GPL Odorizers

Software Release Notes

For GPL750 (XL7) Version 18

Harrison Baer
6-4-2025

Figure 3: Gas Page

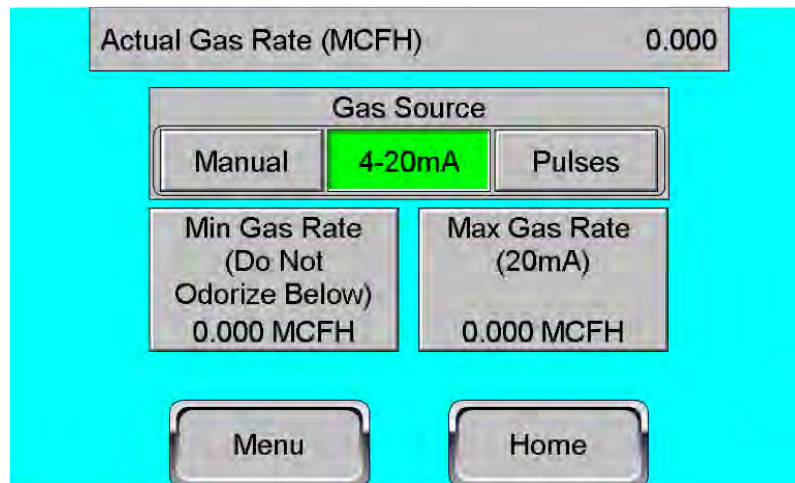
- Removed the “Gas Timeout” setting from the “Pulses” gas source.
- Removed the “Samples to Average” setting from the “4-20mA” gas source.

Figure 4: Home Screen

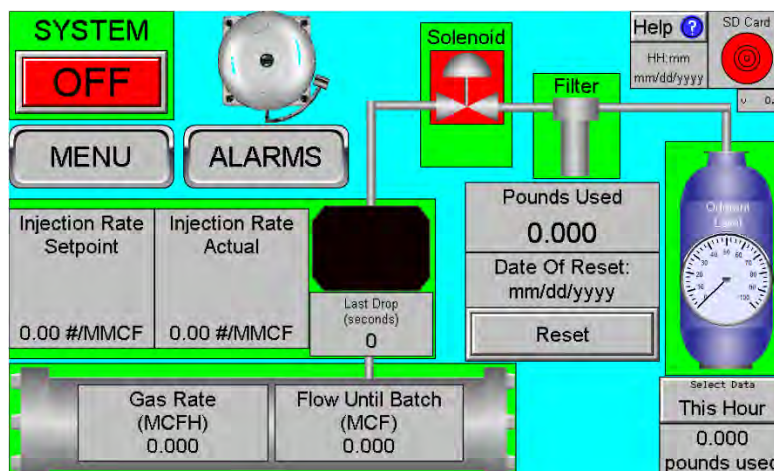
- **Home Screen:** Added date and time display to the top right corner.

Figure 5: I/O Page

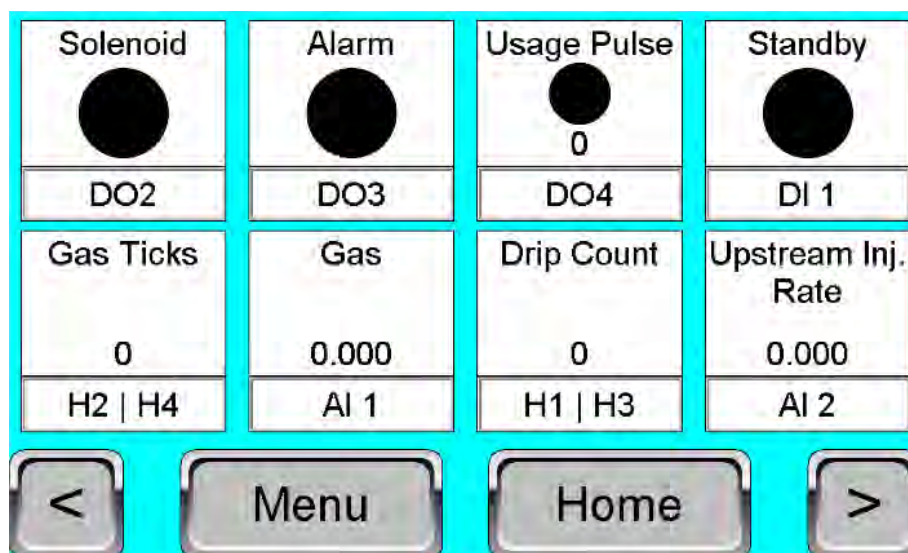
- Relocated Soft I/O to the I/O page and replaced its section on the Main Menu with the Usage page. The I/O page now includes arrow buttons.

Figure 6 & 7: Modbus & IP Configuration Sub-pages

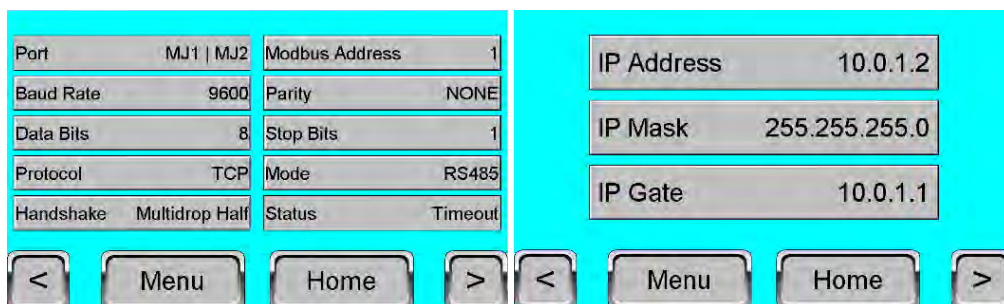
- Separated Modbus and IP configurations to support new Modbus options (see Modbus fixes below).

- Added Modbus Address, Modbus Handshake, and Port settings to the Modbus page.
- Introduced an upper threshold for the Isolation Alarm to reduce false alarms. Drops exceeding 25 per second, as detected by the optical comparator, are disregarded based on fluid dynamics calculations.
- Ensured “Volume Until Batch” no longer updates during a Hi Gas Alarm.
